**From:** Frnc Sinc  
**Sent:** 12 August 2019 17:38  
**To:** Mark Hill; Ailsa Teasdale  
**Subject:** !0StHEnd-Osmotherley-Rev Drwgs C & C1 as discussed

No. 10 SOUTH END - OSNOTH  
PROPOSED ALTERATIONS & CONVEY OF OUTBUILDINGS TO FORM A DWELLING AND ADAPTATIONS EXISTING DWELLING.  
DRN 20 PROPOSED PL.  
SCALE 1:100 AT A2 JULY

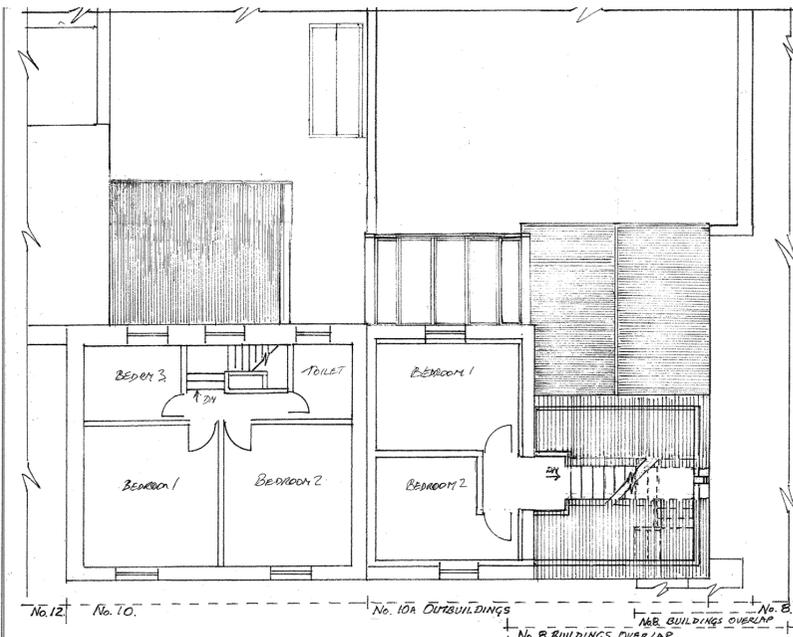
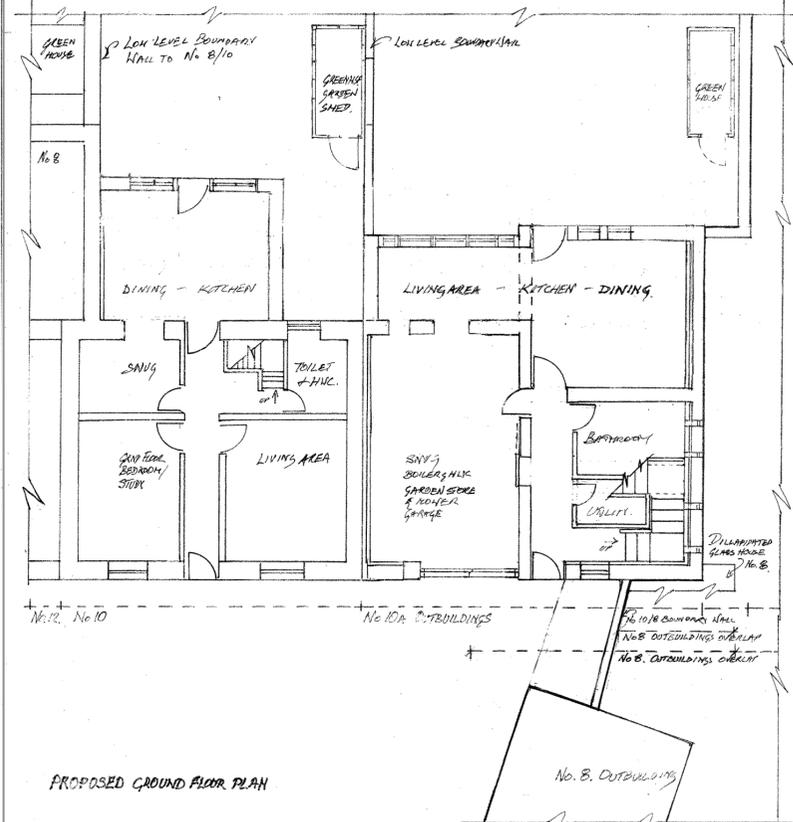
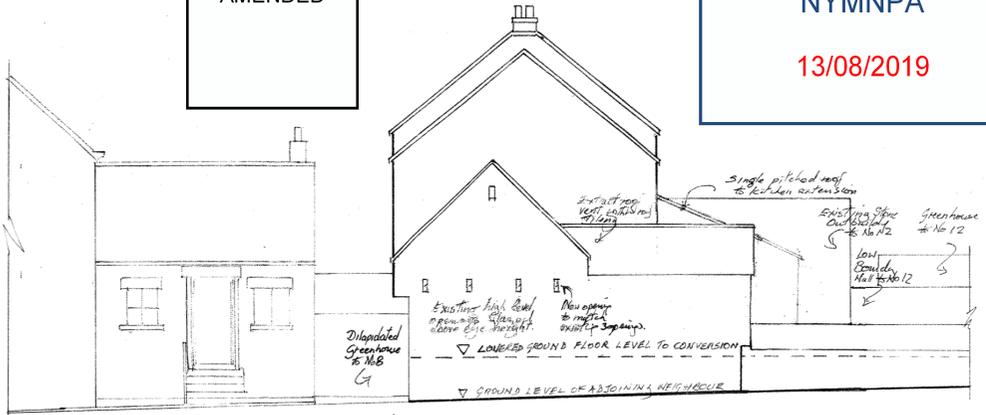
Drwg C shows an extended kitchen in only one direction retaining south elevation as existing with gap showing house as previous required.

Drwg C1 shows as above but without kitchen extension if the former is not accepted.

28Sept 18 Rev A:  
As req -  
Floor level to proposed dwelling lowered to lowest outbuilding  
Roof height of front outbuilding reduced to one and a half storey  
Roof height of pigsty outbuilding lowered with lowest ceiling height 2m above floor level.  
Front elevation - blocked up & retained.  
Kitchen and toilet area reduce pitch to pigsty roof retained at mono pitch extension.  
Rear elevation windows - glazing removed and casements used.  
Gap between kitchen and out extension removed.  
External store shed added.

27 Mar 19 Rev B:  
As req -  
Unsound load bearing walls re in original position - realigned to dwelling south wall - reduced to offset accommodation loss.  
Traditional pitched roofs re-hipped roofs with eaves height retained. West elevation now evidences original roof ridge at hipped roof.  
Outbuilding access retained at brought back into use.  
Full pigsty span and pitch of r retained with agreed eaves at habitable height & openings g New south facing window opening altered to vertical emphasis.  
Stonework to garage lintel rep and lintel altered to match original height.

July 2019 Rev C:  
As req -  
South facing extensions remove kitchen, dining and living area. bedrooms reduced to one and with roof height to outbuilding from one and half storey to or one storey. First floor toilet re with stairs altered.  
Outbuilding extension replace 2m depth set back 300mm, timber framed glazed conservatory with lowered pitch.  
Four ventilation and light slots removed, external roof vent at 5th facing upper floor blocked window reopened to from glass window to bedroom.
